**TOWN OF OCEAN RIDGE
PLANNING & ZONING REGULAR MEETING
AGENDA**

**April 15, 2025 at 9:00 AM
Town Hall - Meeting Chambers**

PLAN REVIEW REPORT
OCEAN CLUB CONDOMINIUM / 6855 N OCEAN BOULEVARD
June 6, 2024 / August 23, 2024 / December 21, 2024

December 20, 2024**To: Kelly Avery, Town Clerk****From: Tara Bamber, PE** **Re: 6855 N Ocean Blvd
Developmental Plan Review
Engenuity Group Project No. 00020.10**

SHEET # PSP.1

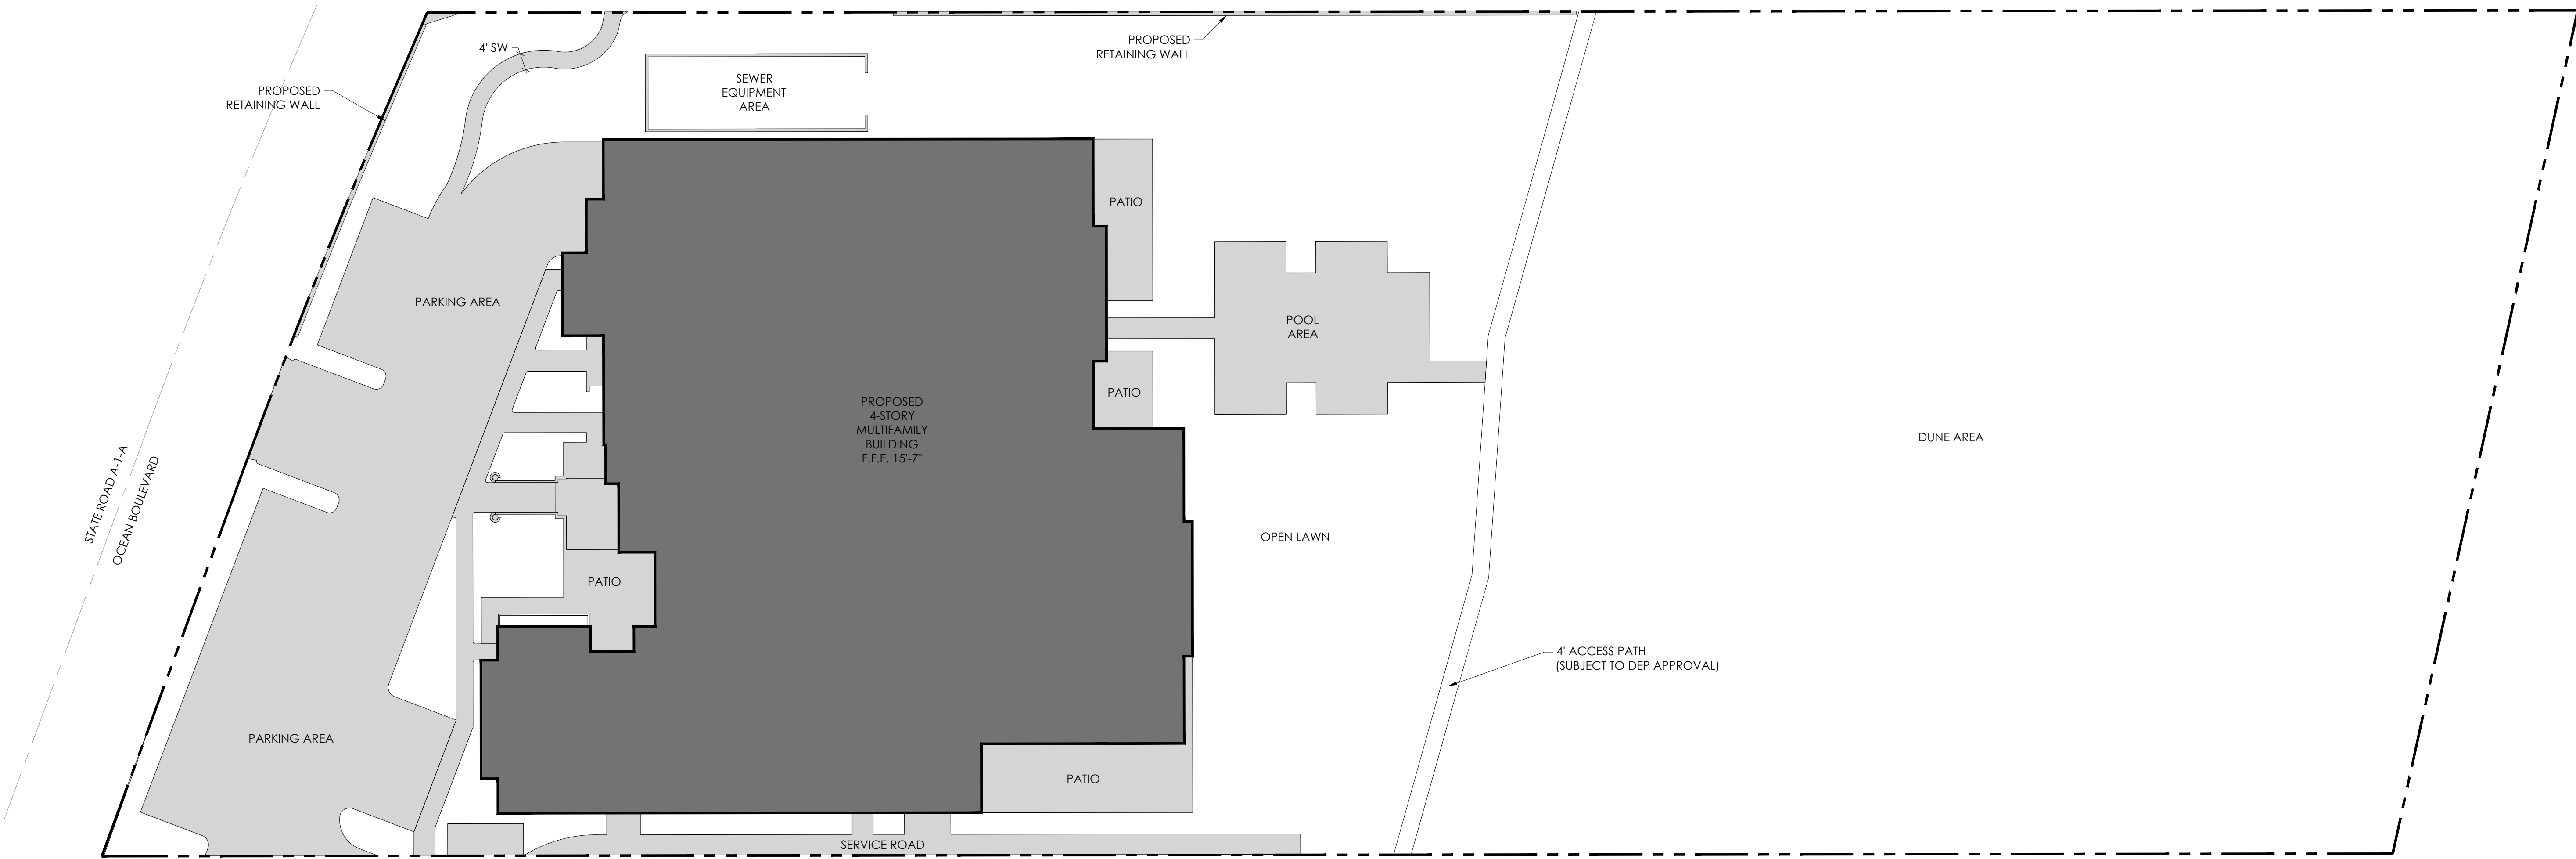
- ~~• Square footage and/or acreage are provided on the LDAA, the survey, the site data on Sheet PSP 1 and in the project narrative, however they do not all include the same figures. Please revise for internal consistency. **Please provide revised LDAA**~~

In addition, Sheet 1 of 2 of the civil plans show the existing parking lot and driveway to be completely removed, and the preliminary site plan Sheet PSP.1 shows a completely reconfigured parking area with the driveway relocated.

A3-0.2

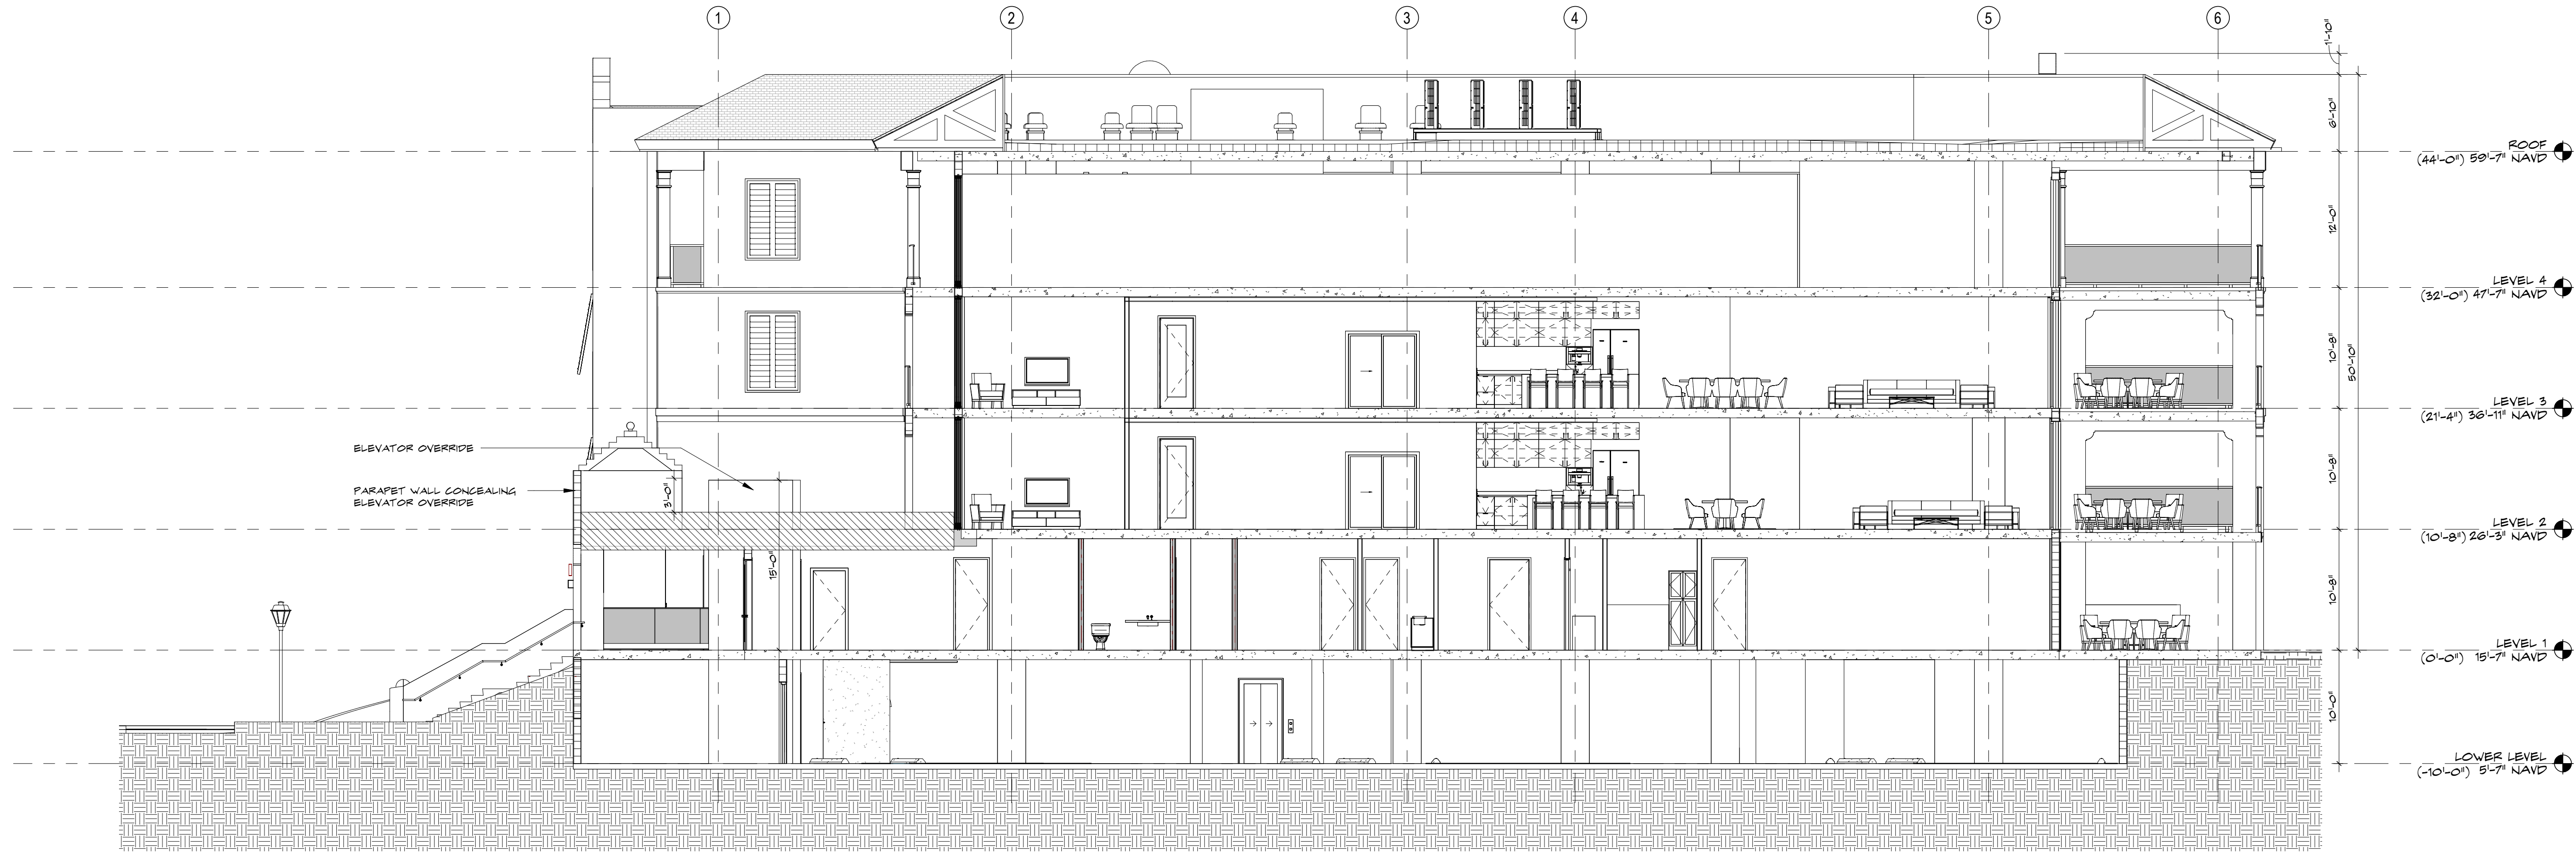
Comment: ~~The elevation sheets A3 0.1, A3 0.2 and A4 0.1 do not appear to show any parapet but show a 6' high mechanical wall which exceeds the maximum height requirements. Please revise to comply with the code language cited, or provide information on how this complies with the Town Codes. **As noted in the resubmittal, code section 64-52 allows height exceptions by "special exception" and while this is not a use exception as defined in section 1-3, this code section does permit height exceptions for mechanical equipment and elevator equipment room, it provides no standards for review. In that regard the revised justification statement provides narrative regarding the height and that it is limited to air conditioning equipment and elevator space, but does not provide justification for the exception. As a condition of approval, the narrative should be expanded to elaborate on why the exception should be approved as information for consideration by the Planning & Zoning Board.**~~ The Justification Statement is revised to include background information on the parapet, rooftop equipment, elevator bulkhead and screening. This report recommends approval subject to consideration by the Planning & Zoning Board.

Comment: ~~Elevation sheets appear to show the rooftop mechanical equipment exceeding the maximum height requirement noted above. Please revise to comply with the code language cited, or provide information on how this complies with the Town Codes.~~ **Comment addressed.**

~~Also note that Sheet A1-2.1 shows 4 roof-top AC units above the 1st floor multipurpose room, and shows elevator space above the 1st floor lobby area. Please show all proposed AC units to ensure adequate screening, and please clarify how the rooftop elevator space is screened (it does not look fully screened on Sheet A3-0.1).~~ **Comment addressed.**

Comment: Elevation sheets appear to show the rooftop elevator space and various mechanical equipment exceeding the maximum height allowance, and the applicant may want to consider including a request for exception to these requirements, alternatively please review the requirements for such structures and provide information on how this complies with the Town Codes. **Comment addressed.**

A101

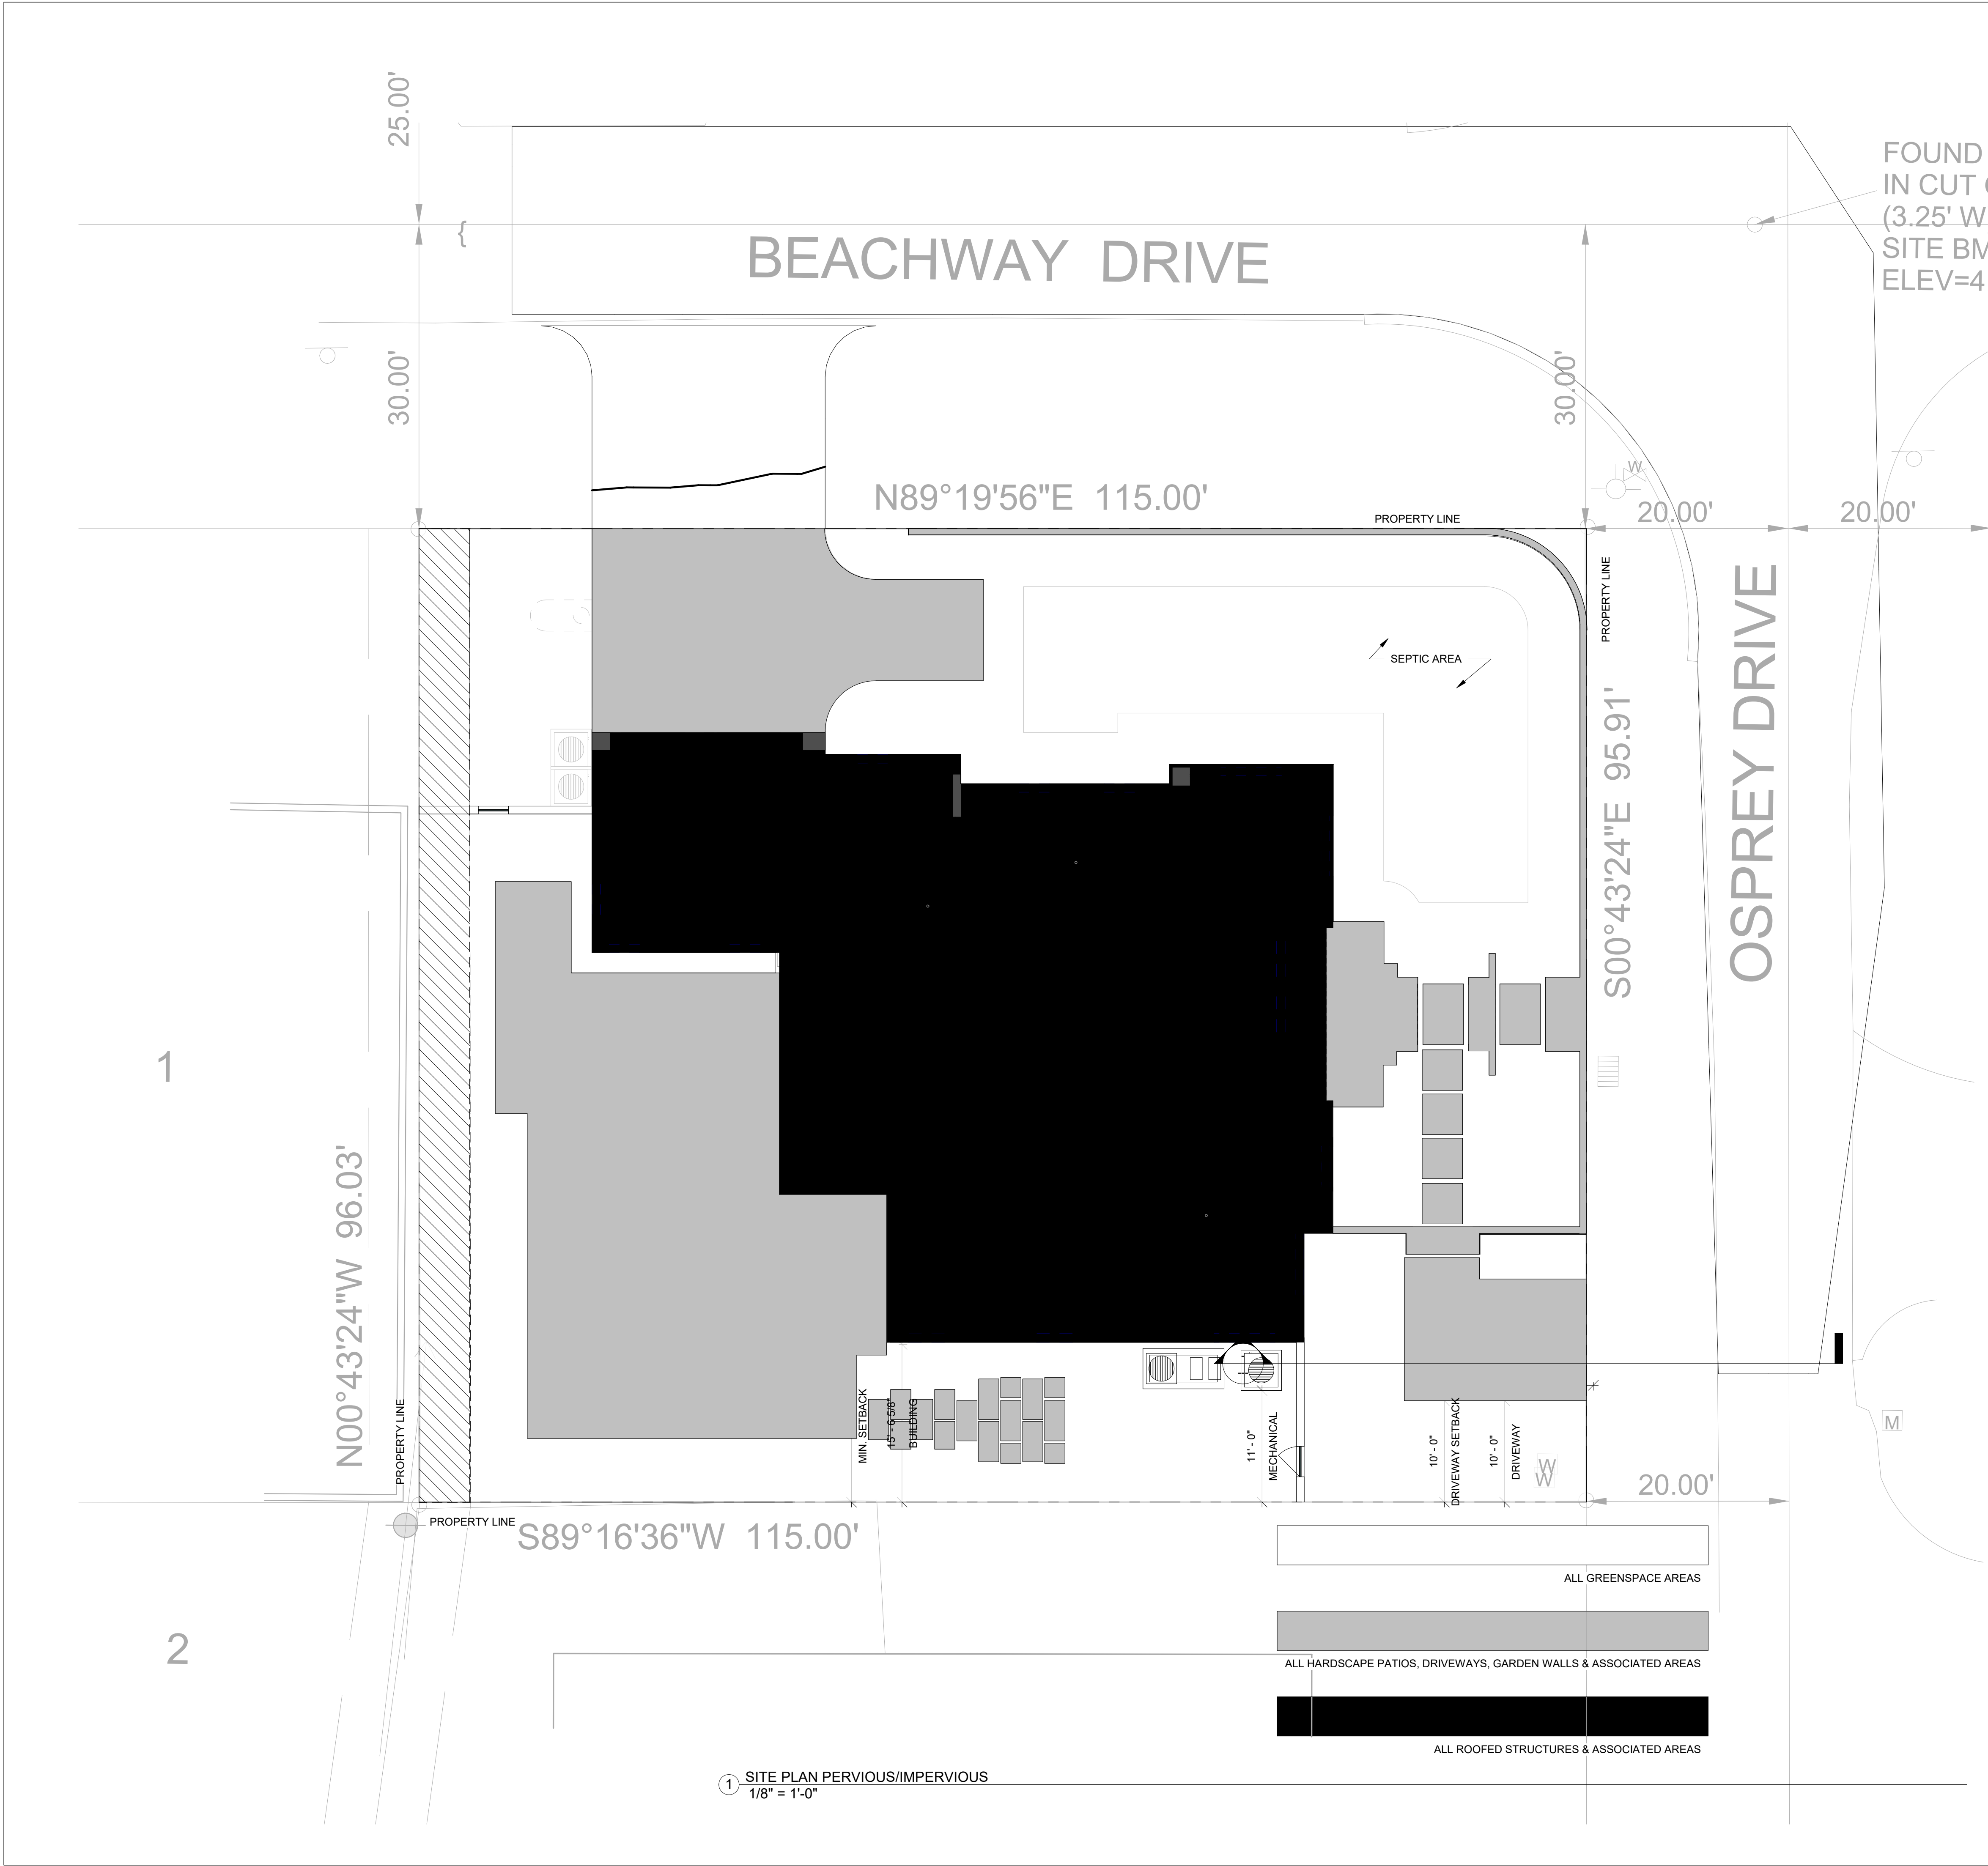
~~Section 64-1(j)(3) Background: This code section limits the overall building height to 36' and states that for pitched roof systems for every foot above 7, there is a corresponding decrease of 1 foot in the maximum building height. The site data on sheet A101 specifies a required maximum building height of 32' and a proposed maximum height of 31' 10", however the finish floor elevation is shown as 9' NAVD. Sheet A301 shows a 32' 2" and sheet A302 shows a height of 32'. If the floor elevation on A101 is correct, the maximum allowable is 34' NAVD.~~

~~Comment: Please revise the sheets A101, A301 and A302 for consistency and to specify the correct maximum allowable height.~~ **Comment addressed.**

~~Section 64-42 (b) Background: This code section permits swimming pools to be setback a minimum of five feet from any side, rear or front property line, provided it is not enclosed and provided that it is not closer than five feet to the primary building. Although Sheet A101 shows a 5-foot setback to the property line, it does not include the dimension to the primary building.~~

~~Comment: Please revise Sheet A101 to include the setback from the principal building.~~ **Condition of approval that the pool shall be setback a minimum of 5' from the building.**

~~Section 64-44 (c) Background: This code section addresses the maximum height of a walls, fences and hedges. Sheet A101 shows a 6' masonry wall with powder coated gate, and a 5' PVC fence. However, it is not clear where the 5' PVC fence begins and ends, and the height of the gate is not specified.~~
